MANDATORY SERVICE BULLETIN

NUMBER: SB11-05
REVISION: 00
DATE: 06/08/2011

SUBJECT: ENGINE DRAIN LINE MODIFICATION

KODIAK 100 Series Aircraft Serial Numbers: 100-0001 through 100-0047, 100-0049, 100-0050, and 100-0052

Figure 1-1: Engine Drain Line Routing Current/Modified

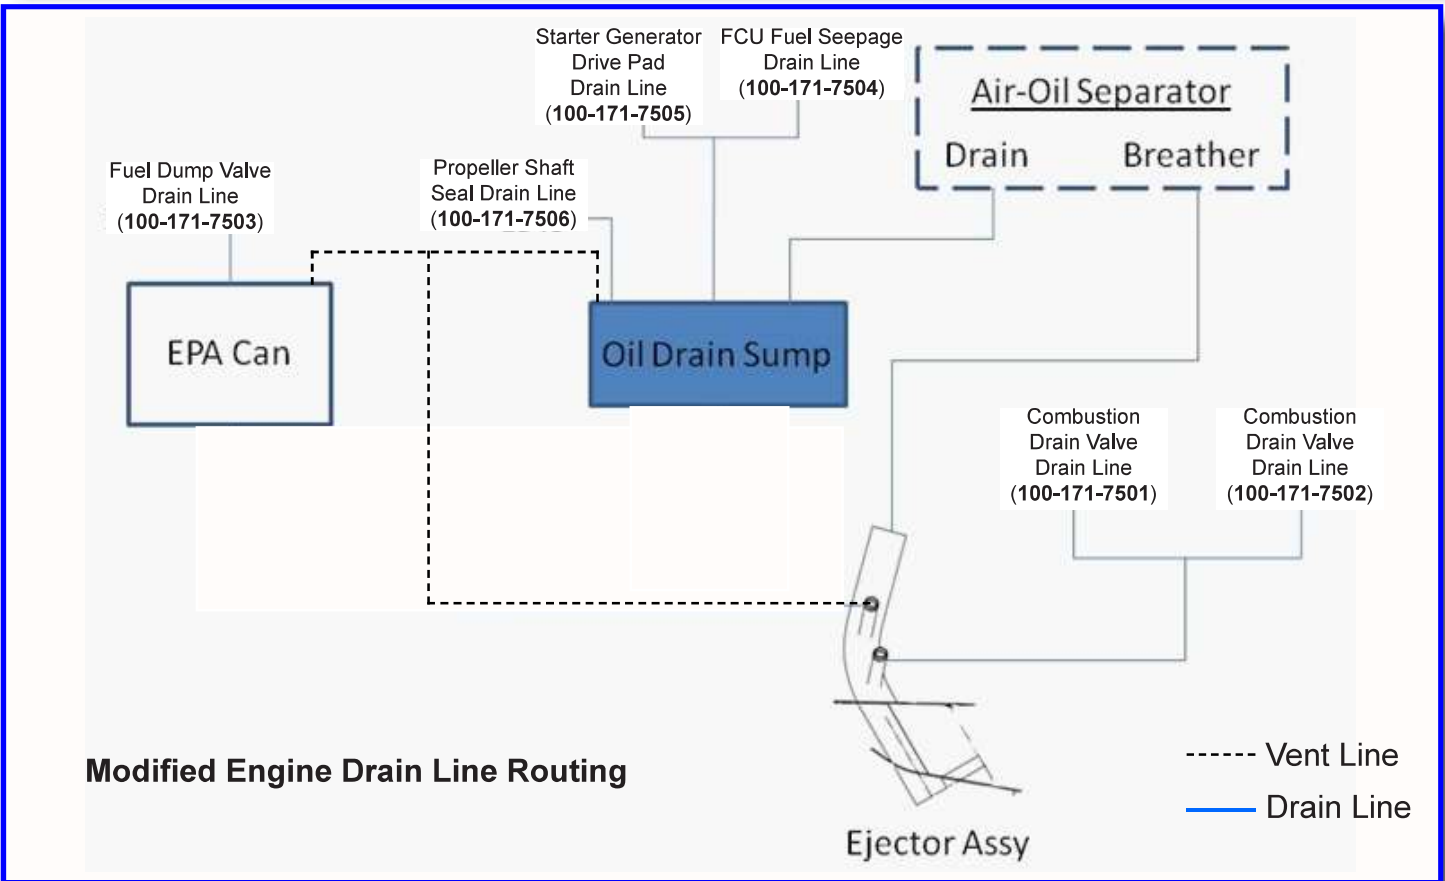
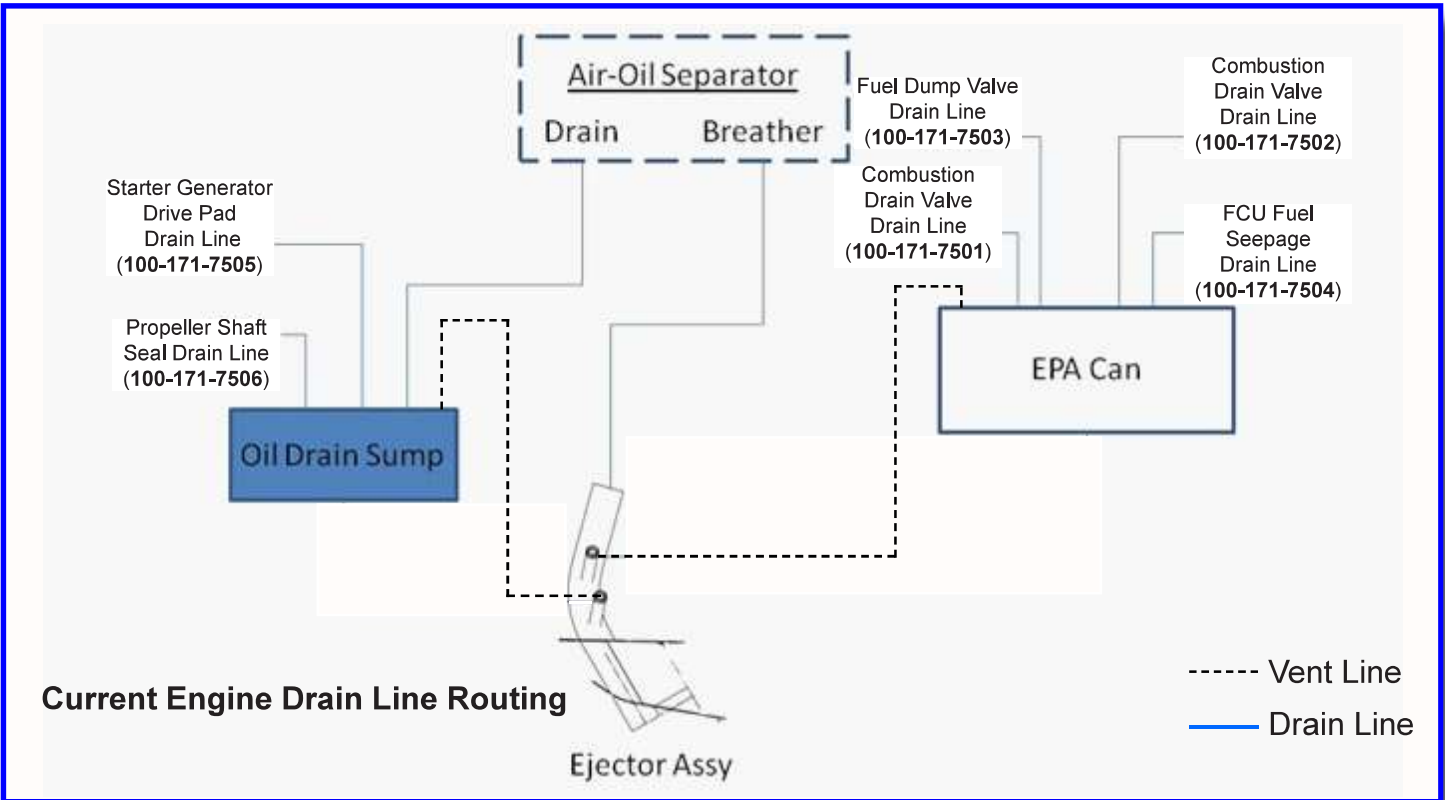
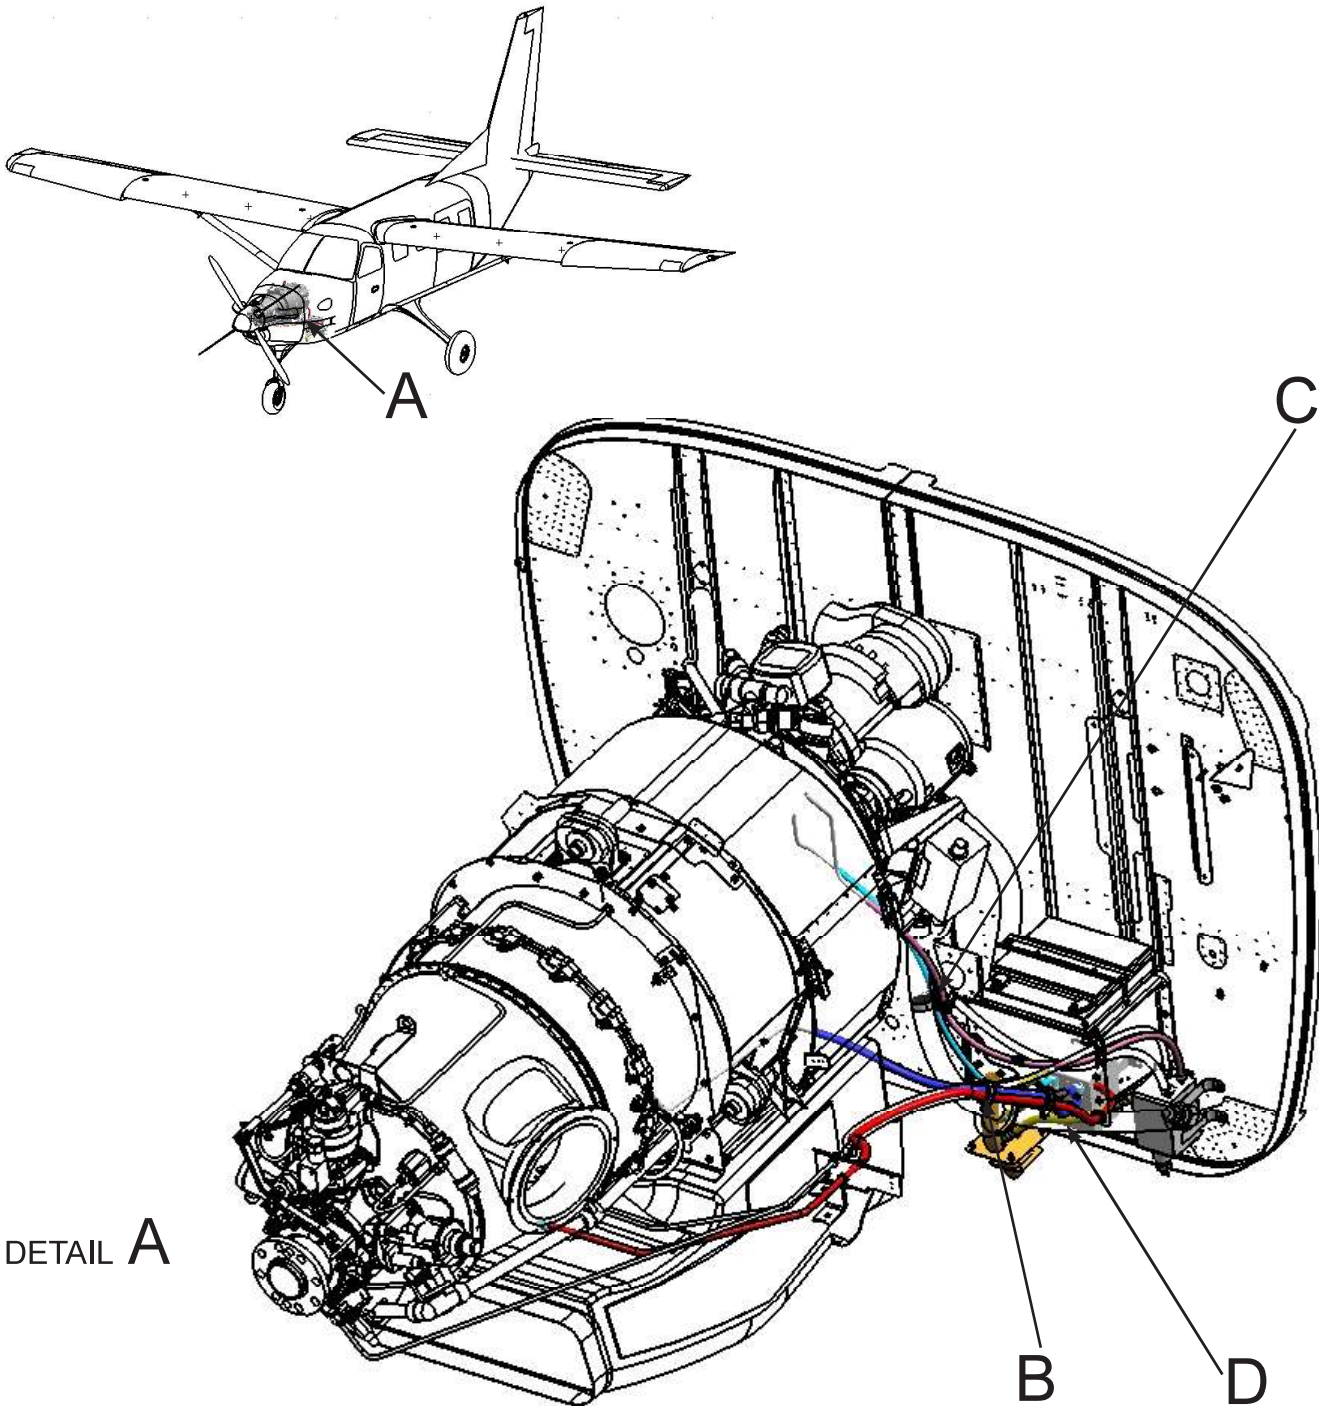
Quest is mandating a one time modification to the engine drain lines. It has been found through company testing that the engine drain lines in their current configuration have the potential to allow fuel to flow back into the Fuel Control Unit (FCU) through the FCU/Fuel Pump Seepage Drain Port. The change described within this Service Bulletin reroutes several engine drain lines.

Quest is mandating a one time modification to the engine drain line routing as outlined in **Figure 1-1**.

In the following steps, refer to **Figure 1-1** for a schematic showing how the current engine drain lines are routed, and how the drain lines should be routed upon completion of this service bulletin.

Figure 1-3 Detail B: Combustion Valve Drain Line Modification

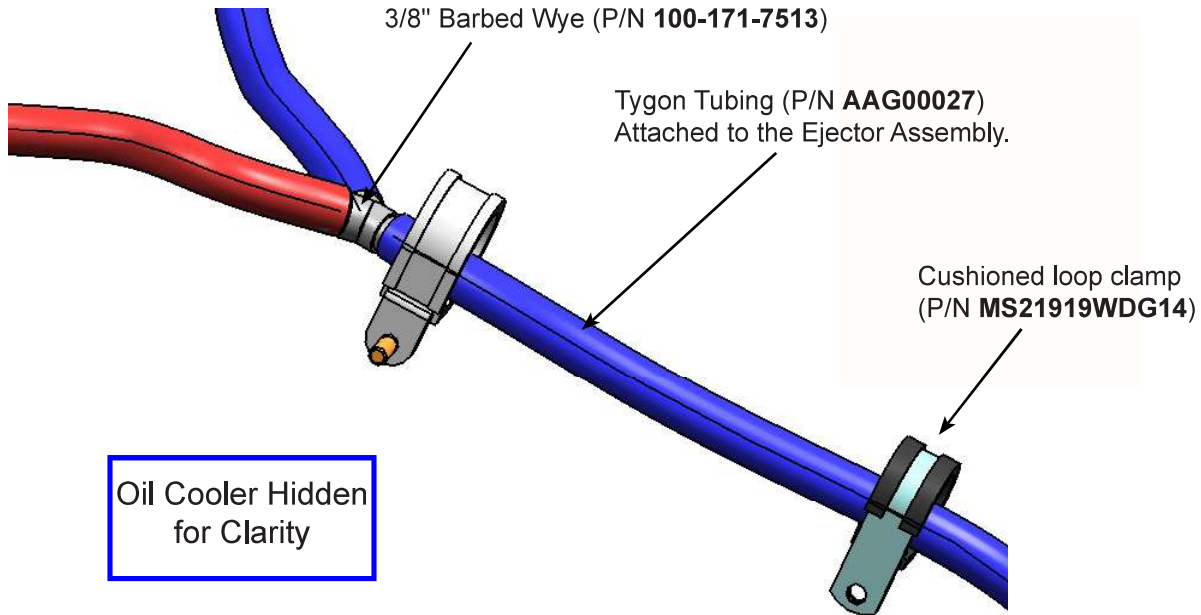
1. Disconnect both drain can overflow Tygon® tubing lines attached to the ejector assembly.
2. Cut the Tygon® tubing coming off each of the combustion chamber drains at the approximate location noted in **Figure 1-3**. Remove the lengths of tubing downstream of the cut.

3. Route a new length of 3/8" Tygon® tubing from the lower ejector assembly spout as shown in **Figure 1-7** up to the cut ends of the combustion chamber drains, and splice them together with a 3/8" Barbed Wye as shown in **Figure 1-3**.

4. Secure tubing to the barbed fitting with zip ties. Secure the new length of tubing to the ejector assembly with the hose clamp.
5. Remove the lower cushioned loop clamp (P/N **MS21919WDG16**) on the inboard side of the oil cooler as shown in **Figure 1-3**, and replace with a smaller cushioned loop clamp (P/N **MS21919WDG14**). Retain the larger clamp for reuse later in **Step #7**.

Figure 1-5 Detail C: Fuel Seepage/Starter Generator Drain Line Modification

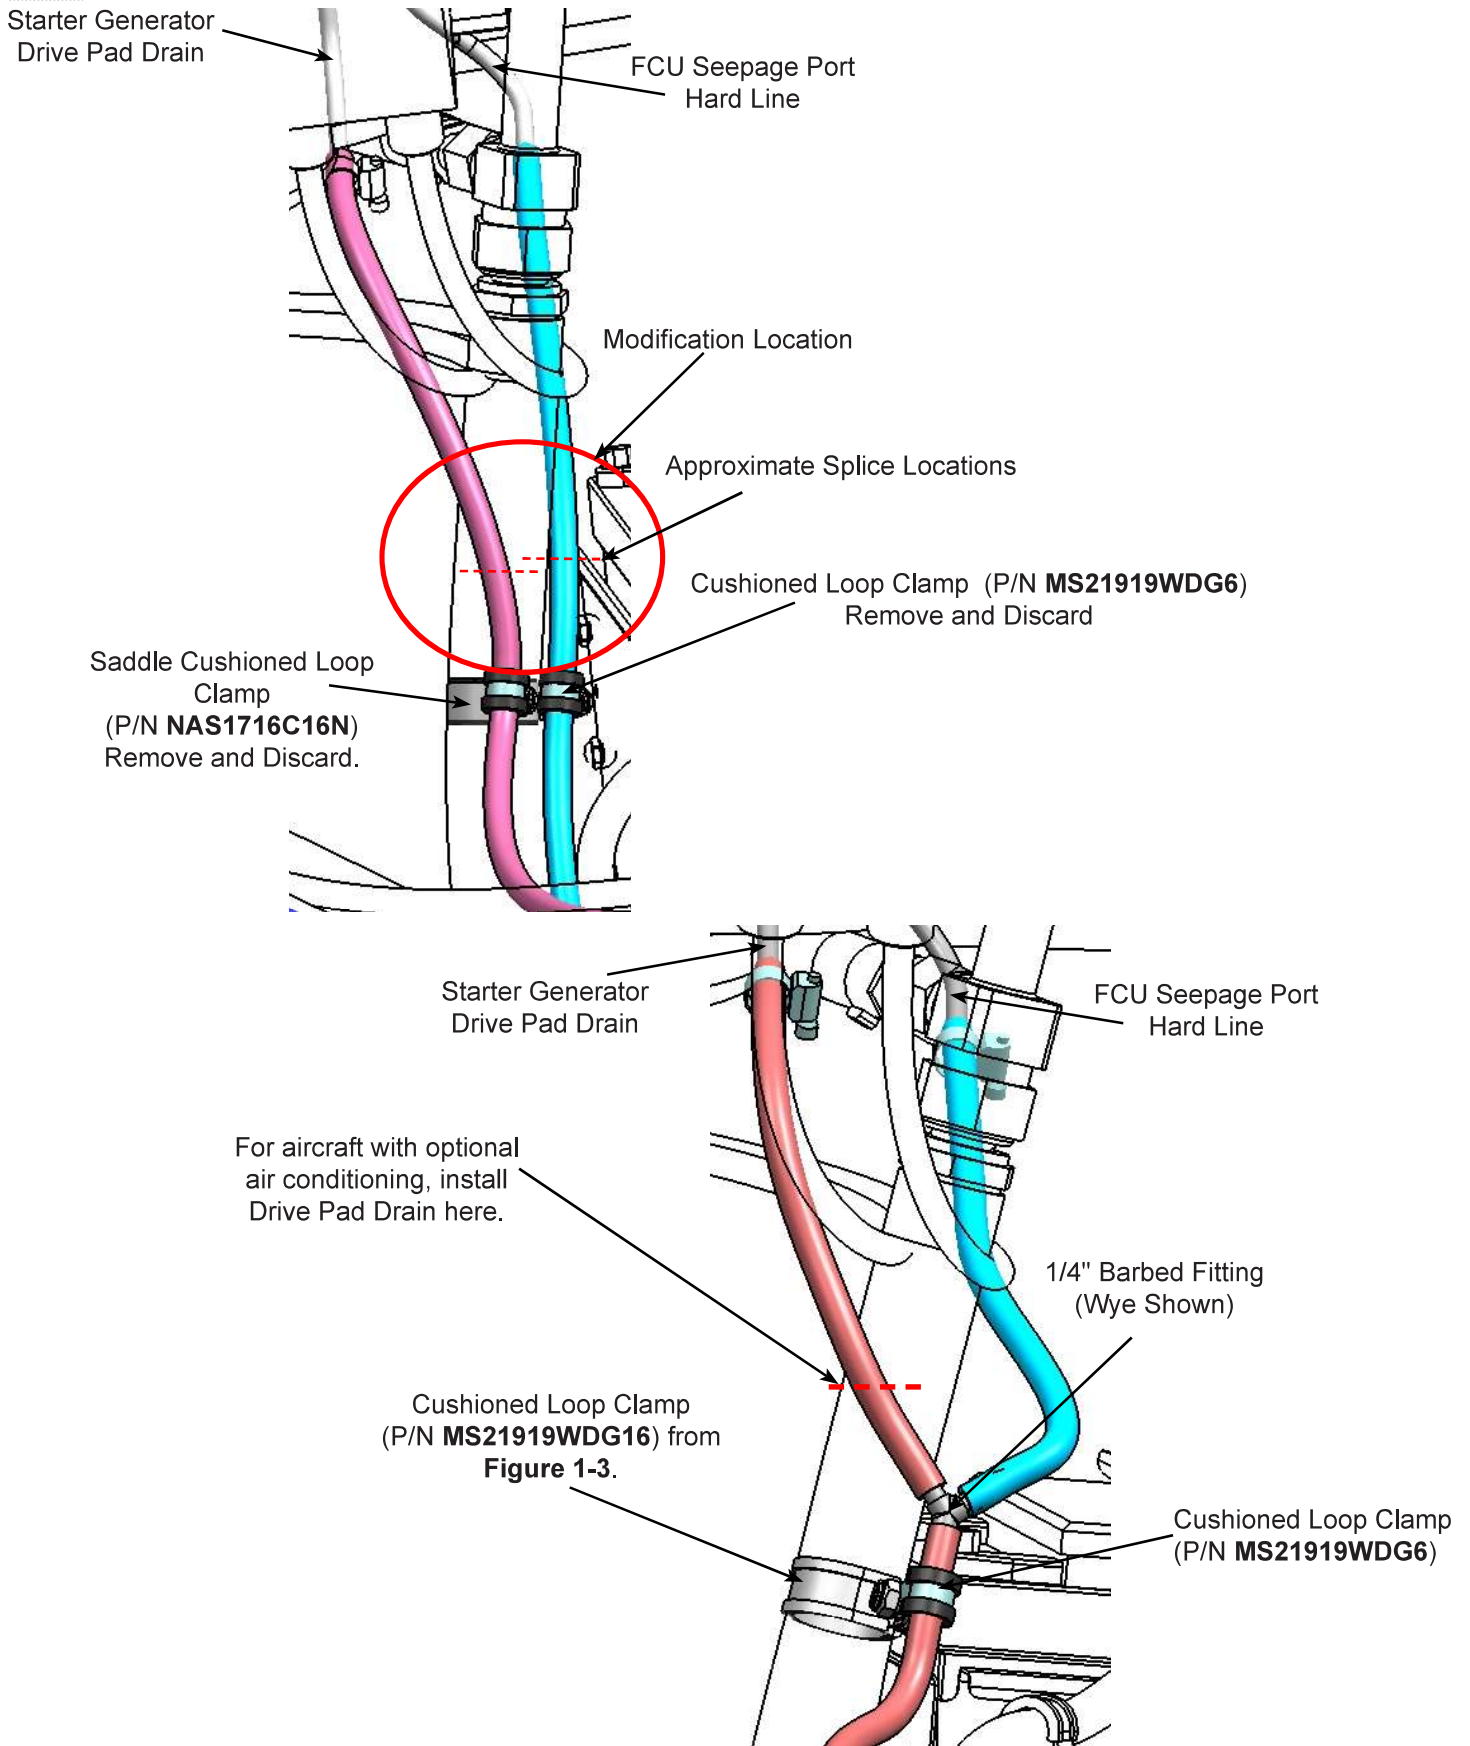
6. Remove and discard the saddle cushion loop clamp and one of the smaller adel clamps that secures the starter generator and FCU seepage drain lines to the oil flex hose as shown in **Figure 1-5**.

8. Remove and discard the entire length of Tygon® tubing coming off the FCU seepage drain port.
9. Install a new length of 1/4" Tygon® tubing extending from the FCU seepage drain port hard line to the location where the large cushioned loop clamp is secured to the oil flex hose, and splice the FCU seepage tubing into the tube coming from the starter generator drive pad drain using a 1/4" Barbed fitting, as shown in **Figure 1-5** and **Figure 1-6**.

Figure 1-7 Detail D: EPA can/Oil Drain Sump Drain Line Modification

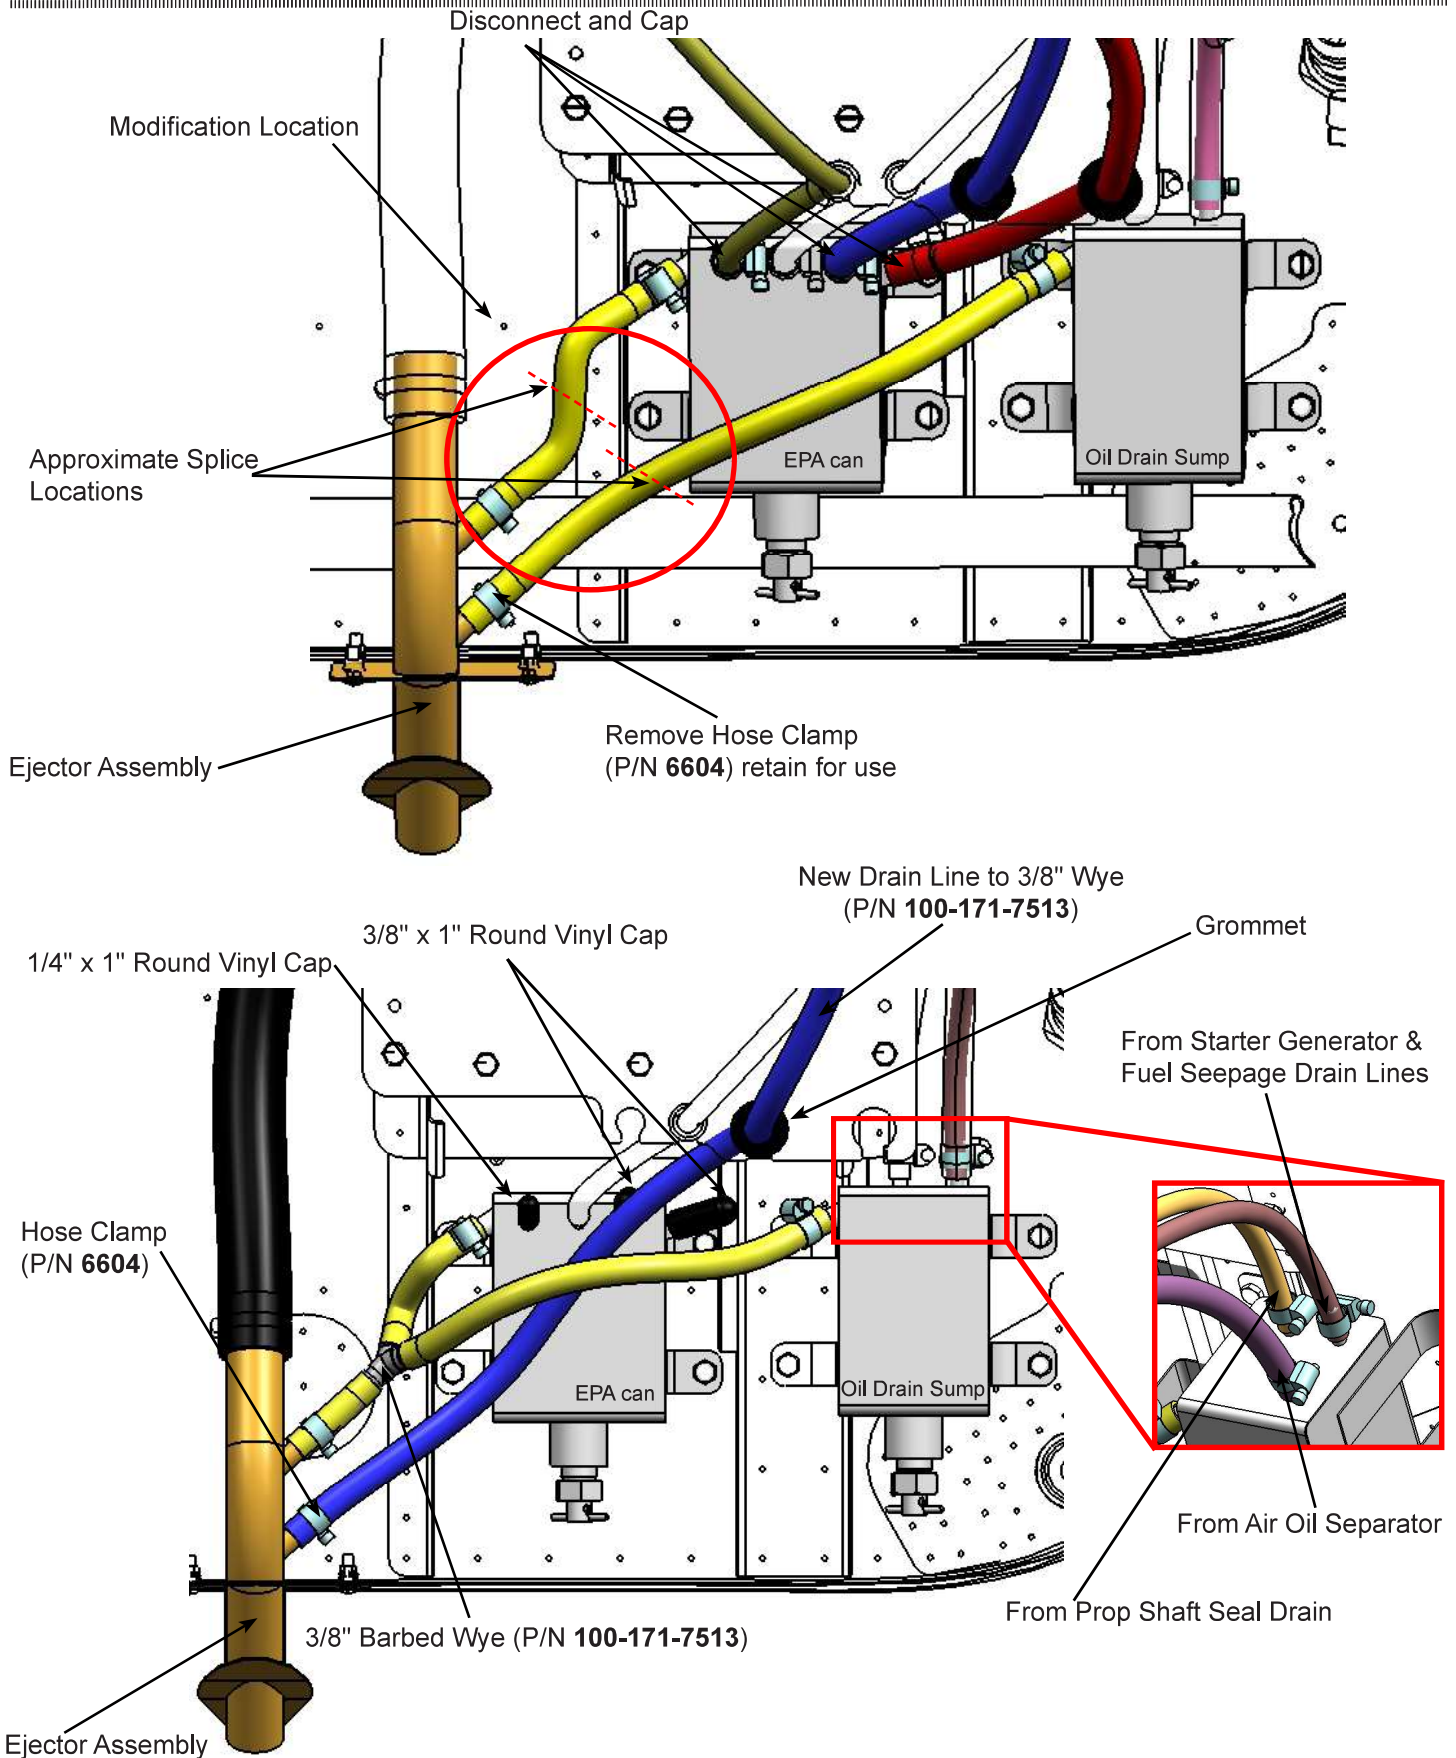
11. In a similar manner, splice the drain can overflow lines together using a 3/8" Barbed Wye, and connect them to the upper spout on the ejector assembly as shown in **Figure 1-7**.

12. Cap the remaining open drain spouts on the EPA can using vinyl caps as shown in **Figure 1-7**.
13. To prevent local accumulation of fluid drainage within the drain lines inspect to the following:
 - A. A positive downward slope in all the tube routing has been maintained.
 - B. No flexible tubing is pinched off by cushioned hose clamps or by excessively tight tube bends.
